DfT Reference: TWA/24/APP/03
Document Ref: CD26-01-APP-W9-3
The Cambourne to Cambridge Order

APPENDICES TO PROOF OF EVIDENCE
of
Jack Southon
of WSP

CAMBOURNE TO CAMBRIDGE (BIN BROOK HYDRAULIC MODEL REVIEW)

Figure 20 - Bank elevation on zlines should be included for interpolates and inbetween to add more details for DTM elevation variations

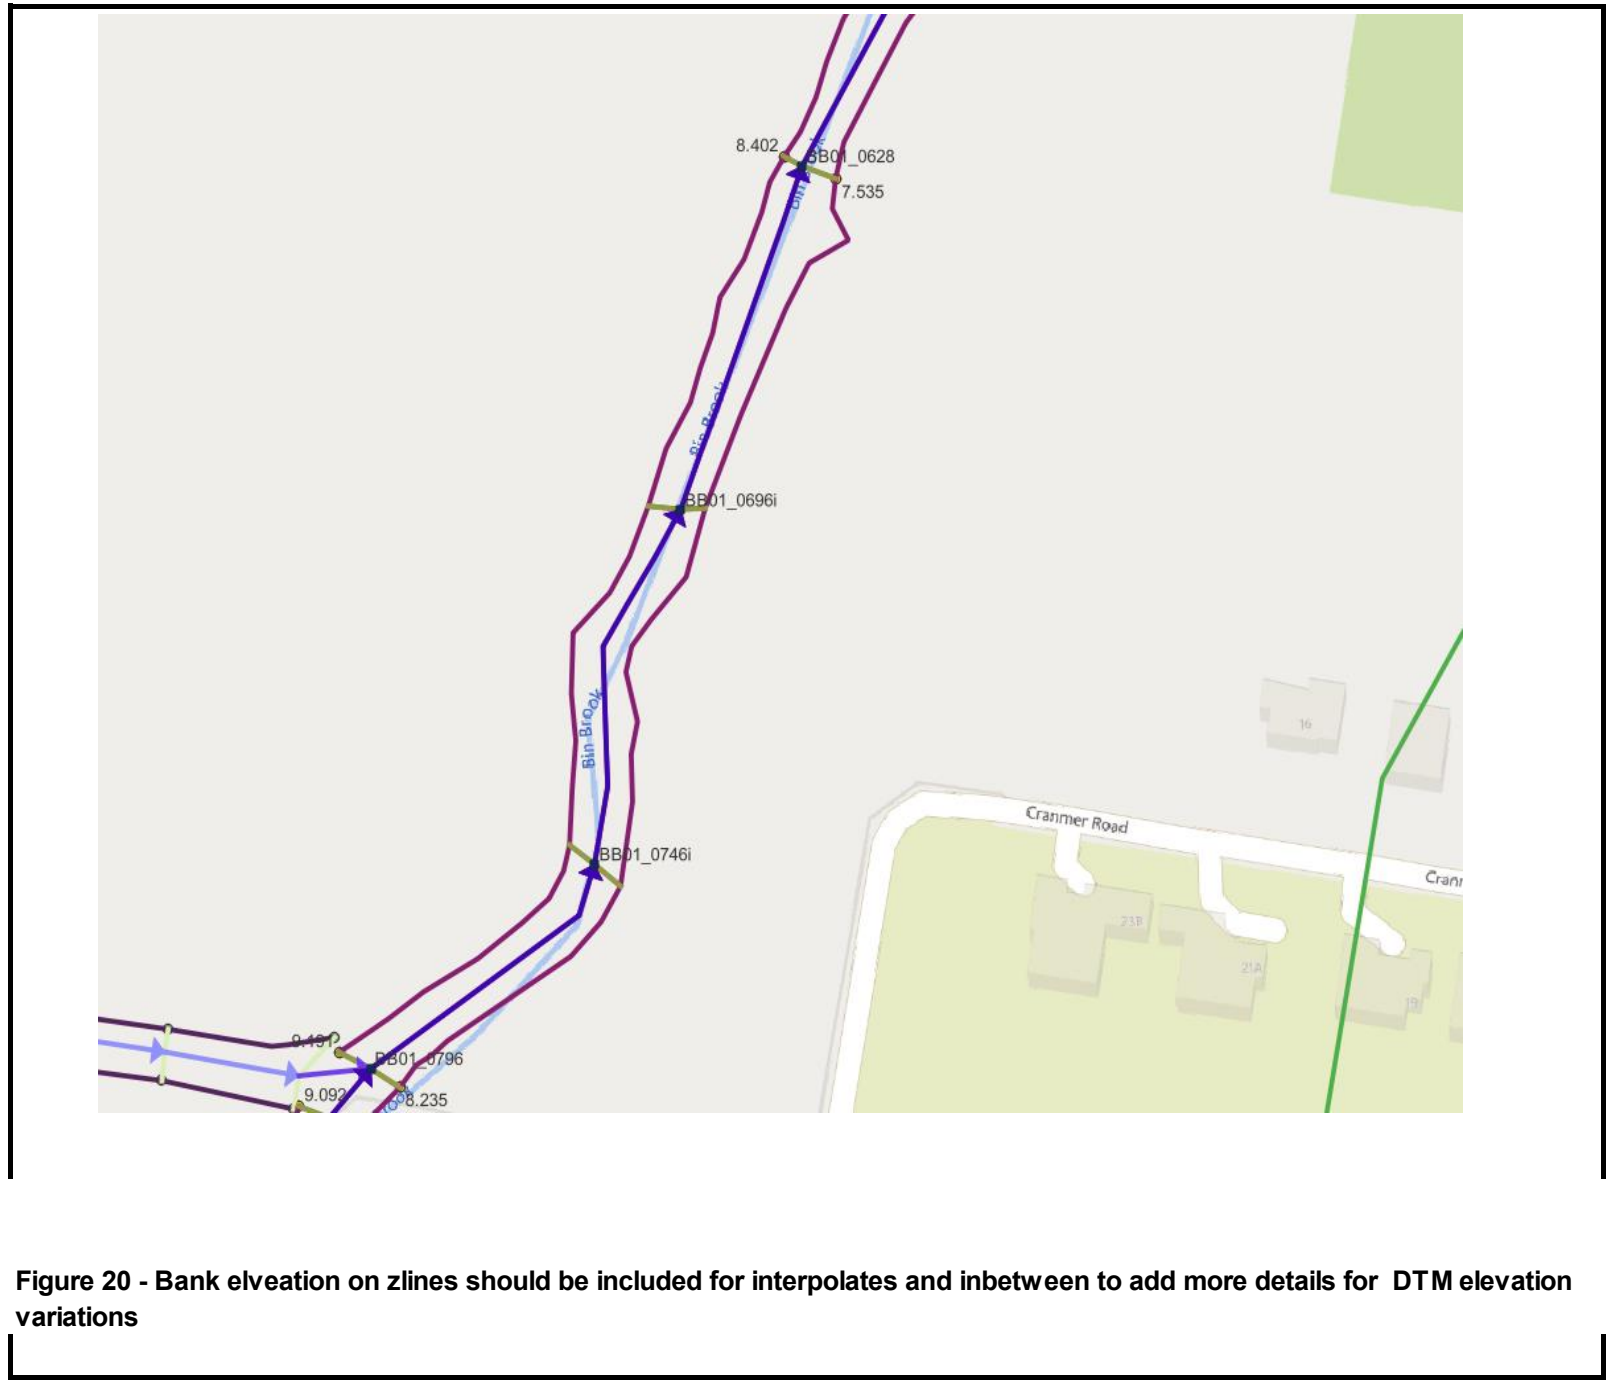
7.9	Are defences/embankments/bank crests accurately represented?	Red	The banks are represented using zlines and zpoints, for both Bin Brook and the ditch which appear to be taken from survey. There are also zlines and zpoints representing the levels of the spills. See 2D_Structures 10.3 for comments on these structures. No other defences or embankments are formally represented. The bankline representation ZSH check shows significant bank raising which appears to be artificially bunding the watercourse Figure 8. Further justification for the bank raising is required.	Check and confirm the bank raising applied at the 102D link location is appropriate. Also see comments in 10.3.	Banklines have been updated to better represent height where there was a large discrepancy between Lidar and bank levels from the model. Checked using zln zpt check layer and reviewing the dZ value.	Red	Please see action in 10.3.	Unclear why there is a red comment here referring to 10.3 (an amber comment). As stated previously Z lines based on survey to supersede LIDAR (the same approach as was adopted by the EA model when updating the 2010 model which used lidar based HX lines). Minor inconsistency for BB01_1471 and BB01_1464 where left bank panel marker has been read in to Z line rather than left deactivation marker value. As the Max command is used this Z line has no

Figure 1: Examples showing large discrepancies (dz) the difference between the Lidar and the assigned bank levels throughout the model.

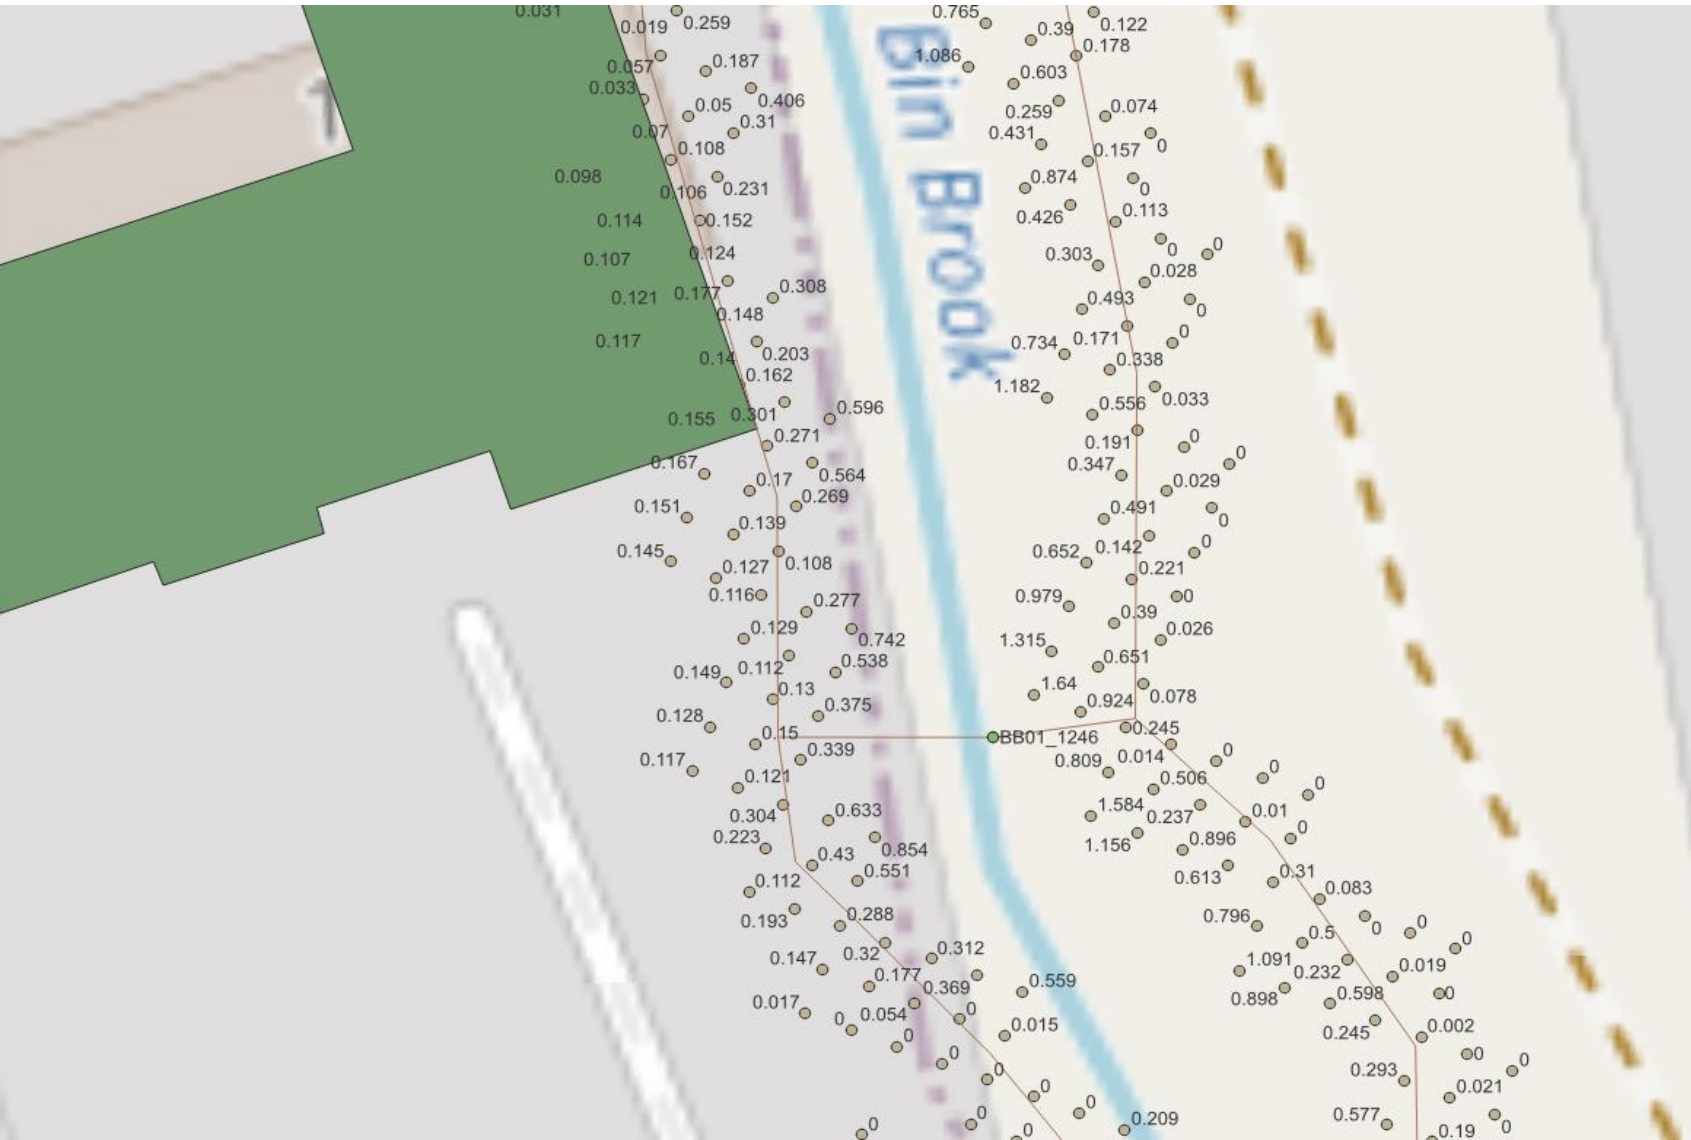
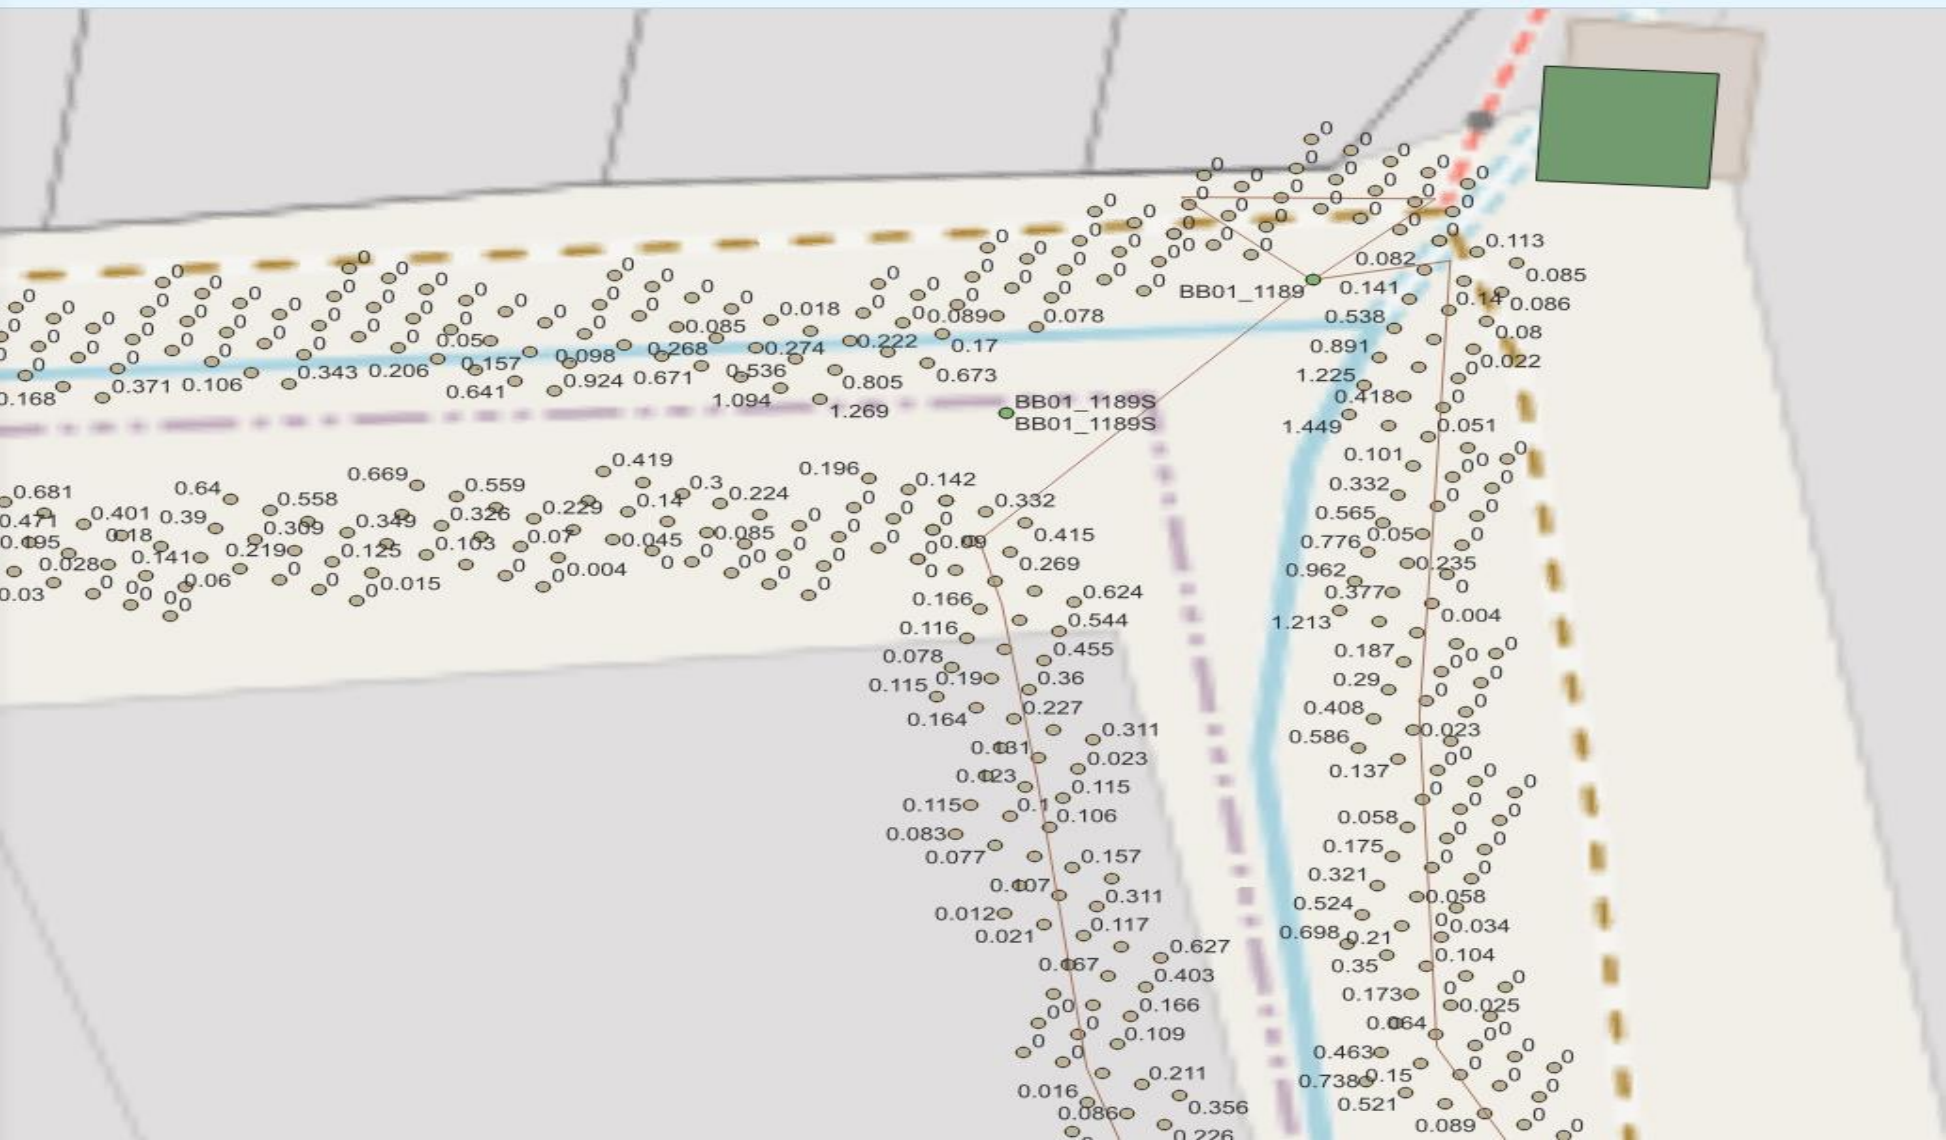
7.9	Are defences/embankments/bank crests accurately represented?	Red	The banks are represented using zlines and zpoints, for both Bin Brook and the ditch which appear to be taken from survey. There are also zlines and zpoints representing the levels of the spills. See 2D_Structures 10.3 for comments on these structures. No other defences or embankments are formally represented. The bankline representation ZSH check shows significant bank raising which appears to be artificially bunding the watercourse Figure 8. Further justification for the bank raising is required.	Check and confirm the bank raising applied at the 1D2D link location is appropriate. Also see comments in 10.3.	Banklines have been updated to better represent height where there was a large discrepancy between Lidar and bank levels from the model. Checked using zln zpt check layer and reviewing the dZ value.	Red	Please see action in 10.3.	Unclear why there is a red comment here referring to 10.3 (an amber comment). As stated previously Z lines based on survey to supersede LIDAR (the same approach as was adopted by the EA model when updating the 2010 model which used lidar based HX lines). Minor inconsistency for BB01_1471 and BB01_1464 where left bank panel marker has been read in to z2 line rather than left deactivation marker value. As the Max command is used this Z line has no impact on model geometry. From review of LIDAR it can be seen that ground levels rise away from the channel and the there is no negative impact from the ZLine. This is noted for future revisions of the model but dose not have the potential to impact the outcome of the study as it impacts both the baseline and proposed equally.	Red	The inconsistency referred to in the second review response is not limited to BB01_1471 and BB01_1464. Significant discrepancies have been identified between the LIDAR data and the assigned bank levels throughout the model (see Figure 1). Please address these discrepancies throughout the model for the next submission.
